Mi propuesta:

Señales Existentes del MUTCD de la FHWA de E.E.U.U, dispositivo R1-6:

Figure 7B-6. In-Street Signs in School Areas

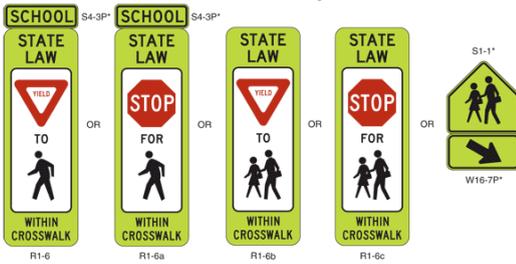
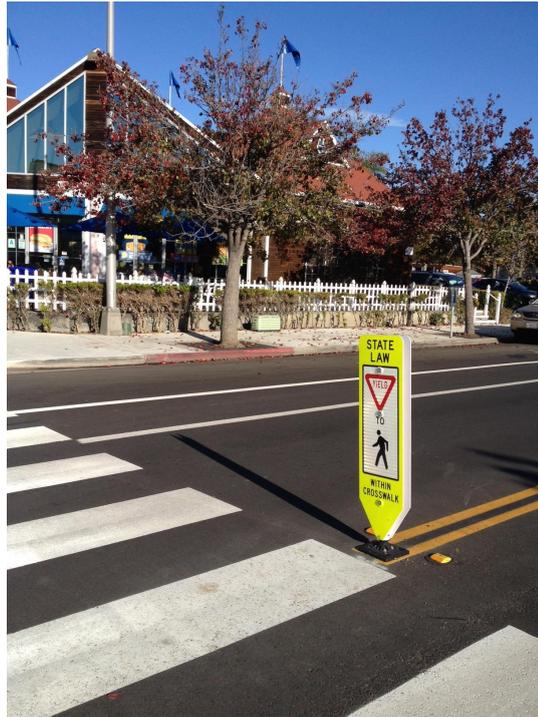
Se menciona que el color fosforescente es para mayor visibilidad. El MDCT solo contempla el amarillo/verde fosforescente para "Señal

vertical preventiva de zona o cruce escolar” con el color Pantone 809. El MUTCD usa el color Pantone 382 en la señal equivalente, el cual se sugiere en el MDCT para distinguir la señal normal de peatones del color designado a cruce escolar pero igualmente brindando alta visibilidad. La restricción se encuentra en el recuadro blanco para indicar la regulación.

Asimismo es importante mencionar que en Estados Unidos, dentro de este dispositivo se usa la señal restrictiva/regulatoria de Ceda el Paso, cuando la ley en el estado es Ceder el paso a peatones, y la señal de alto cuando la ley en el estado es Parar para peatones. En el caso de la CDMX el reglamento de tránsito menciona “cuando haya peatones esperando pasar, los conductores deberán parar y cederles el paso” entonces lo ideal sería usar la señal de Ceda el Paso y no alto, ya que son acciones distintas.
